# Access Compliance Report

## Public Rights-of-Way

### (Curb Ramps)

Intersection ID: 51369	Main Street: UNIVERSITY_CITY_BV	Cross Street: IKEA_BV	Location: NE
ADA ID: CC90BBB851C2	Ramp Type: Perp	Initial Pass/Fail: Fail	Overall Compliance: No
Severity Score: 37.5			
Codes/Mitigation Info/Possible Solution		Field Measurements/Component Compliance

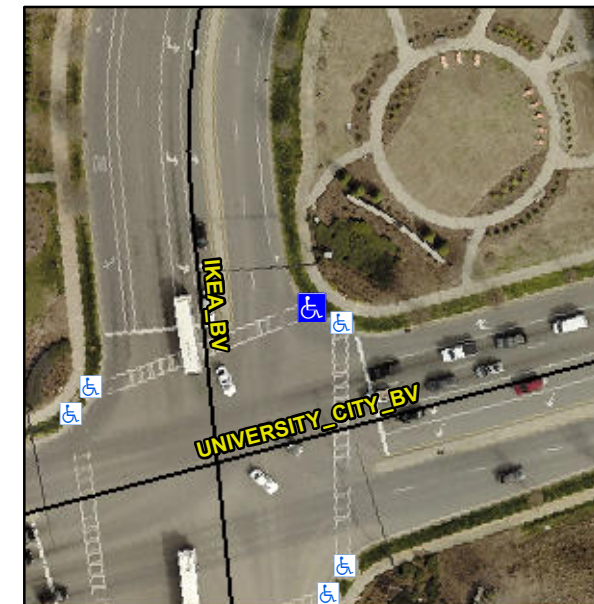
**Not Found, R304.2.2, R304.5.3**

Compliance	Description	Data	Compliance	Description	Data
N/A	Ramp Length (in)	95.0	No	Ramp Slope (%)	8.4
Yes	Ramp Width (in)	48.0	No	Ramp XSlope (%)	7.7
N/A	Flare Type LT	N/A	N/A	Flare Type RT	N/A
N/A	Flare Slope LT (%)	N/A	N/A	Flare Slope RT (%)	N/A
N/A	Flare Traversable LT?	N/A	N/A	Flare Traversable RT?	N/A
N/A	Landing Length (in)	N/A	N/A	DWS Provided?	N/A
N/A	Landing Width (in)	N/A	N/A	DWS Contrast?	N/A
N/A	Landing Slope (%)	N/A	N/A	DWS Length (in)	N/A
N/A	Landing X Slope (%)	N/A	N/A	DWS Full Width?	N/A
N/A	Landing Curb? (Y/N)	N/A	N/A	DWS Offset (in)	N/A
N/A	Shared Landing?	N/A			
N/A	Gutter Ponding?	N/A	N/A	Gutter Slope (%)	N/A
N/A	Gutter Lip Ht (in)	1.0	N/A	Gutter X Slope (%)	N/A
N/A	Painted X Walk1?	Yes	N/A	Painted X Walk2?	N/A
	X Walk 1 Direction	To W		X Walk 2 Direction	N/A
N/A	X Walk 1 Width (in)	80.0	N/A	X Walk 2 Width (in)	N/A
	X Walk 1 Slope (%)	2.9		X Walk 2 Slope (%)	N/A
	X Walk 1 X Slope (%)	5.5		X Walk 2 X Slope (%)	N/A

**Remove & Replace Entire Ramp.**
